Form: **Addendum No. 1**
Project Title: **RFP 1646 Courtyard Lighting: University Hall**
Issued Date: **December 18, 2025**
Revised Submission Due Date: **January 21, 2026 at 2:00 p.m.**

SECTION 1:
QUESTIONS & ANSWERS

EXISTING BUILDING FIRST FLOOR AND CRAWLSPACE PLANS

LOWER
LEVEL
FLOOR
PLAN

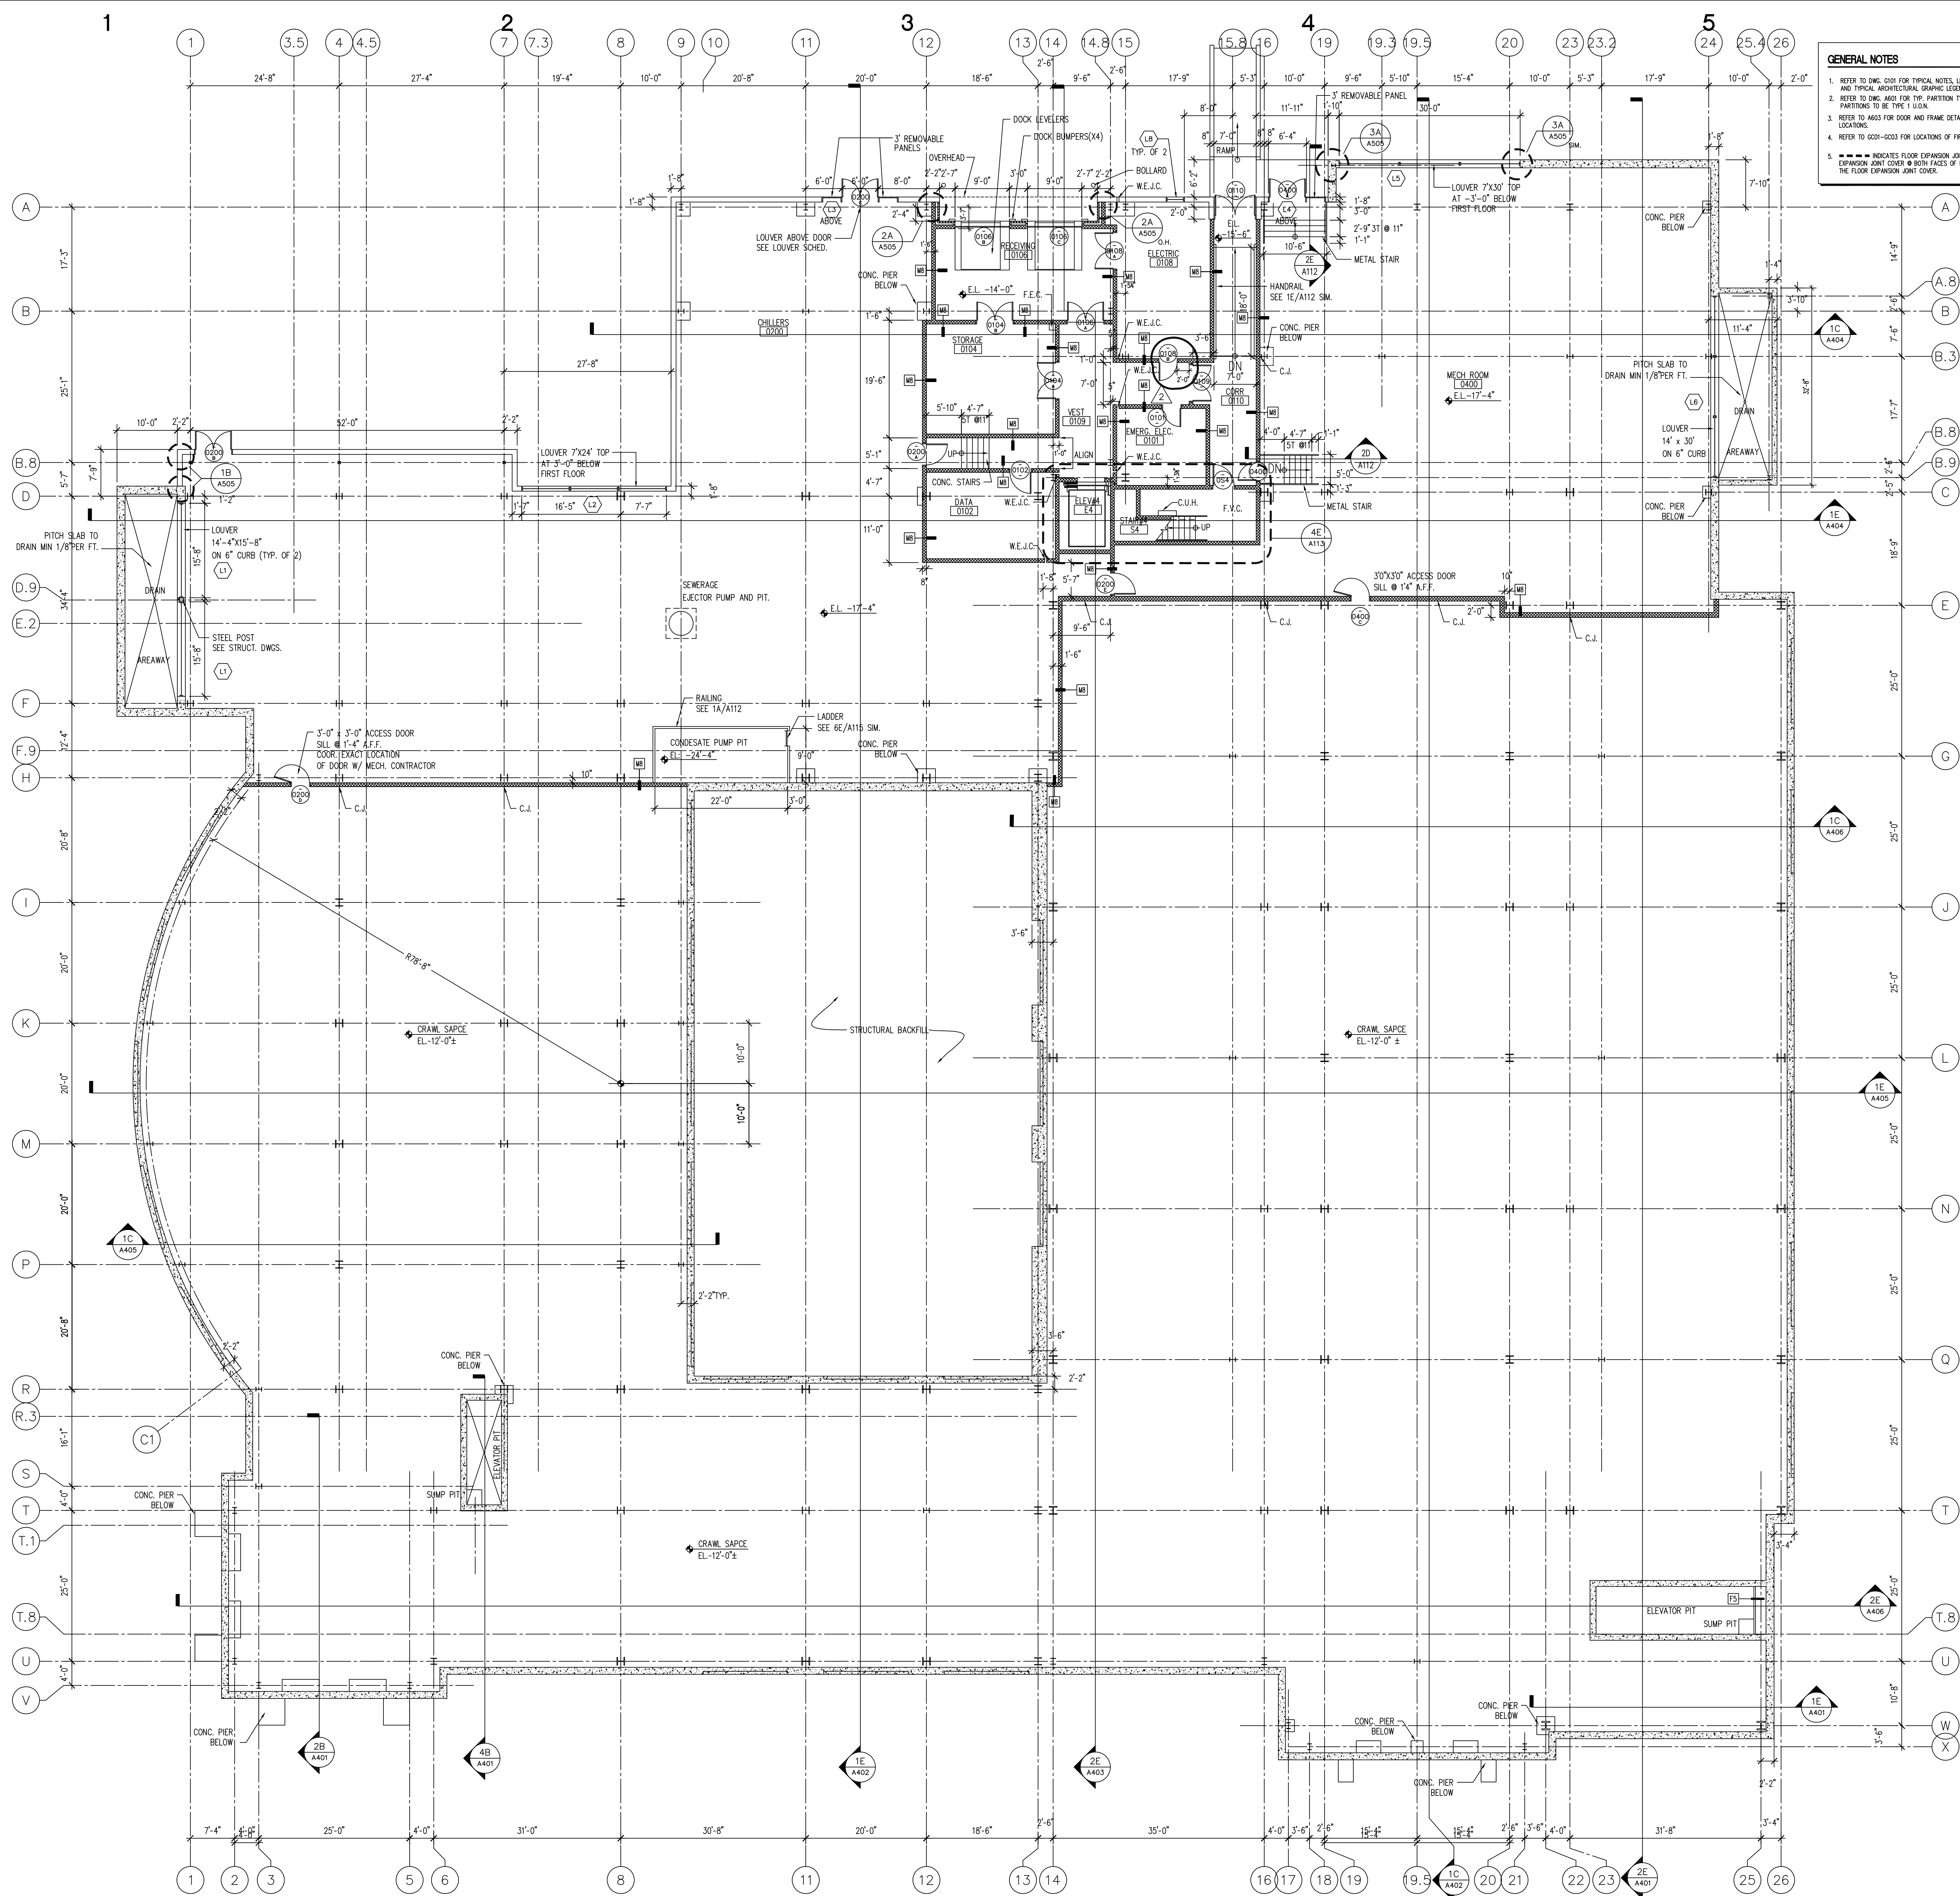
8	Question & Answer
Drawing E-101	
Electrical Keyed Note:	
1) Can you provide a floor plan of the entire floor of the building, showing area of work and locations of electric closets, so we can review path and distances. The distances illustrated on the drawings are not representative of actual conditions on site.	
See attached existing building first floor and crawlspace plans, A 100 and A 101. Existing Electric Room is Room 1107.

9	Question & Answer
Drawing E-101	
Electrical Keyed Note:	
1) Please indicate path for installation of the electric conduits from the two electric closets to the court yard atrium.	
See attached existing building first floor and crawlspace plans, A 100 and A 101. Existing Electric Room is Room 1107.

10	Question & Answer
Drawing E-101:	
The drawings seem to indicate we dig a trench from each light pole to the next, then from the last pole to the courtyard exterior wall, then how do you want the conduits to get to the electric closets? Surface mounted on exterior or interior walls? Trench the floor? Is there a basement? A general note of home run to panel without some path indicated and some discussion of the finishes to be disrupted is not enough of a scope for level bidding. There are high hard ceilings inside the building, carpeted floors, millwork on wall, etc. please clarify pathway and scope.	
The courtyard is on earth, there is no slab underneath. The building foundation walls around the courtyard are the walls of the mechanical crawl space below. Conduit route will be through the crawlspace walls into the subsurface of the courtyard. See attached existing building first floor and crawlspace plans.
